**Before the
FEDERAL COMMUNICATIONS COMMISSION
Washington, D.C. 20554**

In the Matter of)	
)	
Applications for Public Safety Pool (Conventional))	File Nos. 0004331029
Licenses in the 433-445 MHz Band for Mobile Use)	<i>et al.</i>
of ReconRobotics Video and Audio Surveillance)	
Systems and Associated Waiver Requests)

REPLY TO OPPOSITION TO PETITIONS TO DENY

Errors and Issues in the Testing and Certification of the ReconRobotics Recon Scout

Figure 1 - This graph from the test-result report shows the measured bandwidth of the Scout when operated on with an apparent video carrier at 445 MHz.

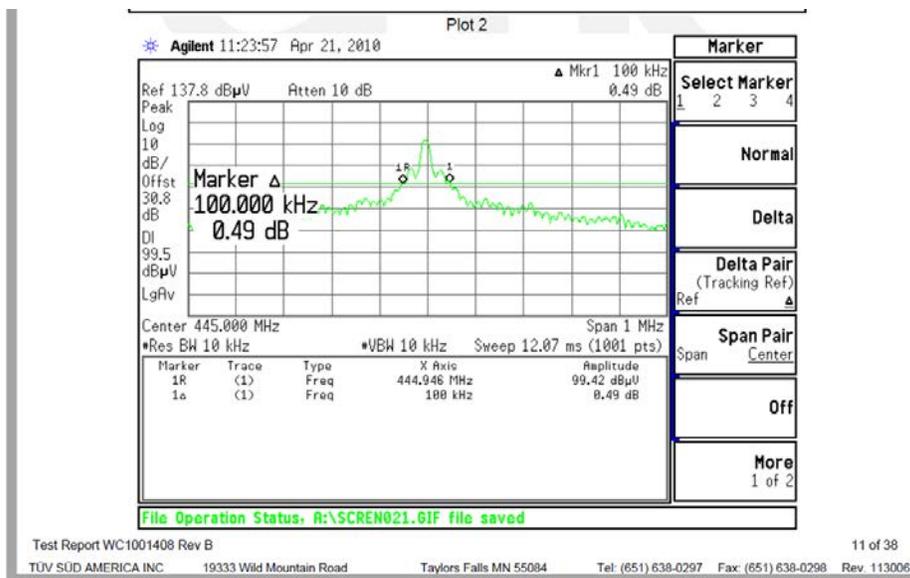
Figure 1 below, taken from the ReconRobotics Scout test-result report, shows the reported occupied bandwidth of the transmitter. This measurement is by no means representative of the bandwidth of an NTSC analog video signal. Part 2 is not explicit as to the modulation test conditions for a transmitter using C3F emissions, but the loosest possible interpretation of the rules would allow the use of the provision of §2.1049(i):

This provision notwithstanding, it is clear from the test results that the modulation applied to the device was far from that which would produce a typical bandwidth reasonably representative of the actual necessary bandwidth for an AM vestigial-sideband video transmitter. The results look closer to what would be seen if the Scout camera were looking at a well-lit room with few features. (Not surprisingly, this could describe a typical shielded test room.) Although it is recognized that it is not practical, nor typical, to apply an external video signal to the Scout, it is also technically incorrect to make a measurement of occupied bandwidth that does not specify in any way the modulation conditions or input signal (as required by §2.1049(i)) especially when the result is obviously so radically different than the known necessary bandwidth of an NTSC video transmitter. It would be much more reasonable to measure the occupied bandwidth under the darkest lighting conditions apt to be reasonably and typically encountered by the Scout, as this is the modulation that would produce the greatest, not the least, energy in the modulation sidebands. Having apparently made this measurement to the standards which apply to an FM or PM transmitter, using a -20 dB criterion for establishing occupied bandwidth simply compounded this testing error to the point where the end results don't even make sense. In this context, ReconRobotics' continuing justification of the emissions designator and the bandwidth testing is inexplicable.

The test conditions that existed when the occupied bandwidth measurement of Figure 1 was taken were neither typical nor a reasonable representation of the occupied bandwidth that would be encountered in actual use. Figures 2 and 3 below show measurements of

What is evident from the comparison of the bandwidth of the signal transmitted during the testing of the Scout and the bandwidth of the two extremes of the ranges seen in Figures 2 and 3 above is that the modulation of the Scout was not close to the modulation that would produce a reasonable representation of the range of occupied bandwidth that would be seen during typical operation of the device under test. This is another area where the test result report does not support a certification grant, and therefore the applications that specified the erroneous emission designator in the certification grant are in error as well.

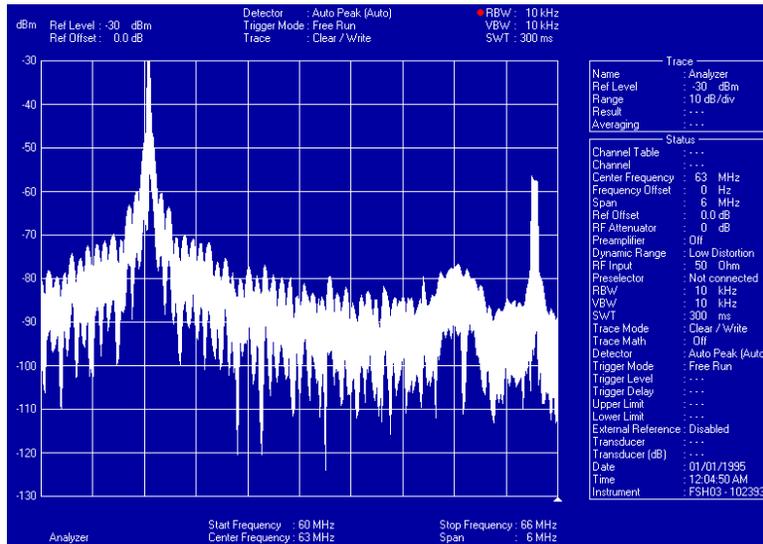
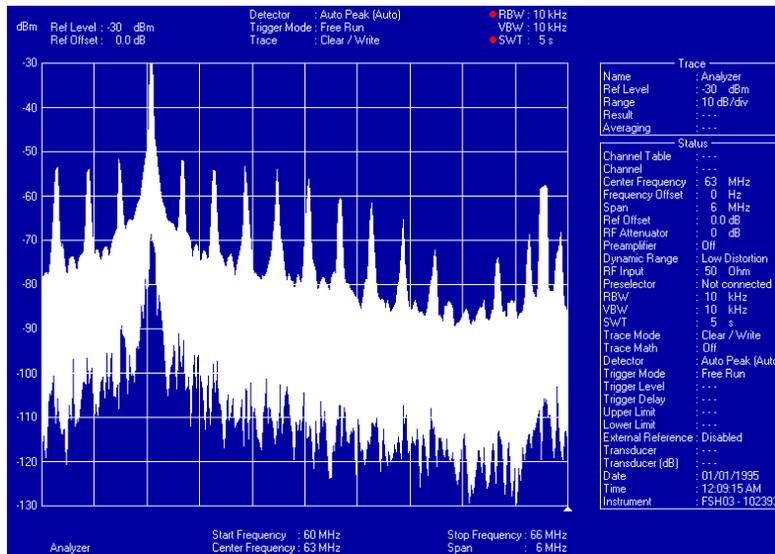
the RF output of an NTSC generator under two modulation conditions – a blank raster and a crosshatch. The crosshatch is a common video test signal.
